Hudson Hilltop Self-Storage Expansion Site Plan Review

Staff Report
13 January 2016

SITE: 22 Brady Drive -- Map 105/Lot 017 -- SP# 11 – 15

Re: Town of Hudson Planning Board Review
Hudson Hilltop Self-Storage Expansion (Site Plan)
Tax Map 105, Lot 17; Acct. #1350-871
CLD Reference No. 03-0249.1490

CHAIN LINK FENCE DETAIL

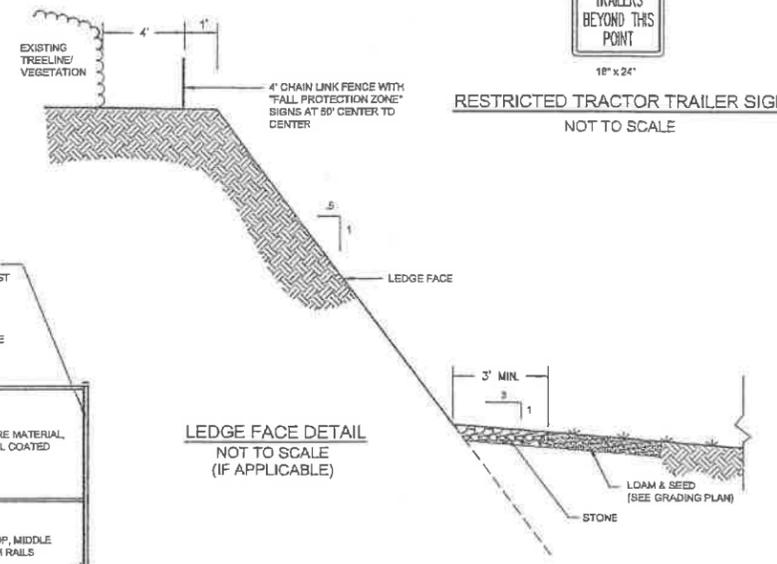
3. In regard to the landscape waiver request, one may think that no landscaping being provided by the Applicant is somewhat of an excessive waiver request. However, on the other hand, it appears that the Applicant plans to maintain a substantial natural landscape buffer to the rear of the site, leading to the Twin Meadow Dr. residential neighborhood. Also, a permanent 8 ft. in-height chain link fence is proposed around the perimeter of the developed portion of the site – replicating the fence surrounding Phase 1 of this self-storage complex. See fence installation locations on Sheet 4 and fence details on Sheet 10 of 15.

BEAM GUARDRAIL DETAIL
NOT TO SCALE
(MARCH 2008)

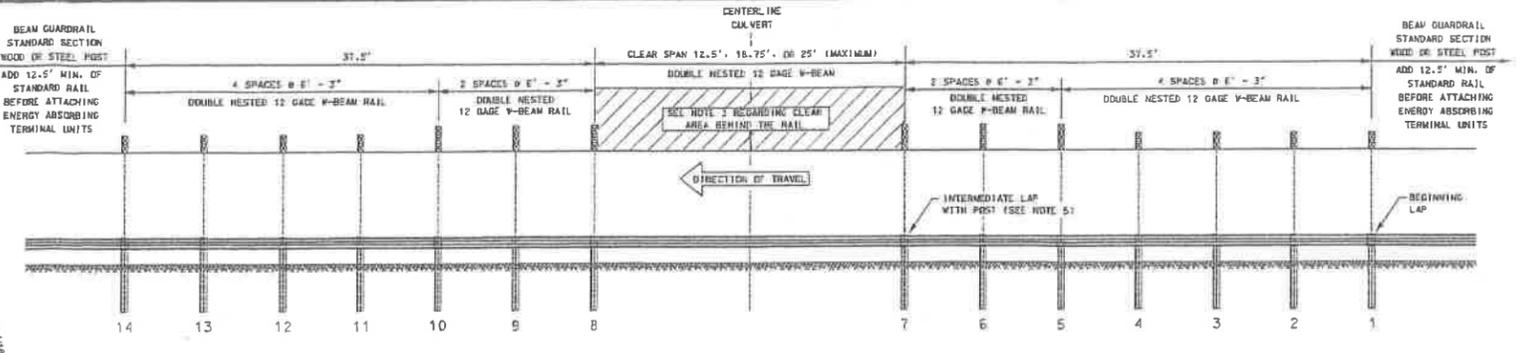
- a. *Former CLD Comment: The applicant should provide additional details for the installation of proposed guardrail. The plans appear to show relatively abrupt changes in line where the guardrail crosses the box culvert. The applicant should also provide guardrail warrant evaluation calculations, demonstrating that proposed guardrail length and layout is adequate for the proposed grading.*

Current CLD Comment: The applicant has revised the guardrail layout to remove the abrupt changes in line. The applicant did not provide warrant evaluation calculations but noted that the guardrail has been provided along the retaining wall and box culvert and at the 2:1 slope leading down to the stormwater pond. CLD is unable to verify if proposed guardrail locations are adequate.
